Access Compliance Report

Public Rights-of-Way

(Curb Ramps)

Intersection ID: 8687	Main Street: MCDONALD_ST	Cross Street: REMINGTON_ST	Location: SW
ADA ID: 2AF2BF04C8B0	Ramp Type: BlendTrans1	Initial Pass/Fail: Pass	Overall Compliance: No
		Severity Score: 25

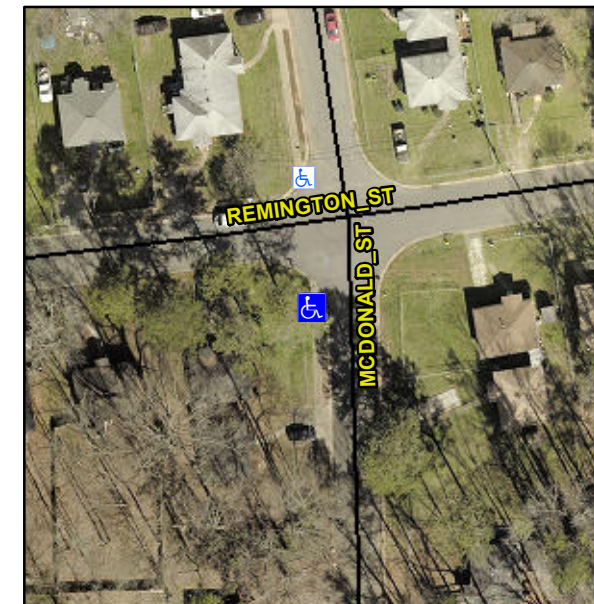
Not Found, R304.5.3, R305, R302.7.2

N/A	Ramp inside XWalk1?	N/A	N/A	Ramp inside XWalk2?	N/A
	Road Slope (%)	1.7		Clear Space?	Yes
	Road X Slope (%)	2.2	N/A	Clear Space to XWalk (in)	N/A
Yes	Any Obstructions?	No	Yes	Storm Grate/Utility Hazard?	No
	Obstruction Type			Storm Grate/Utility Type	
		N/A			N/A
			Yes	Surface Condition? (G/P)	Good
			No	Curb Slope (%)	8.7

Remove & Replace Curb Ramp With Two New Directional Ramps or Equivalent. Remove & Replace Gutter.
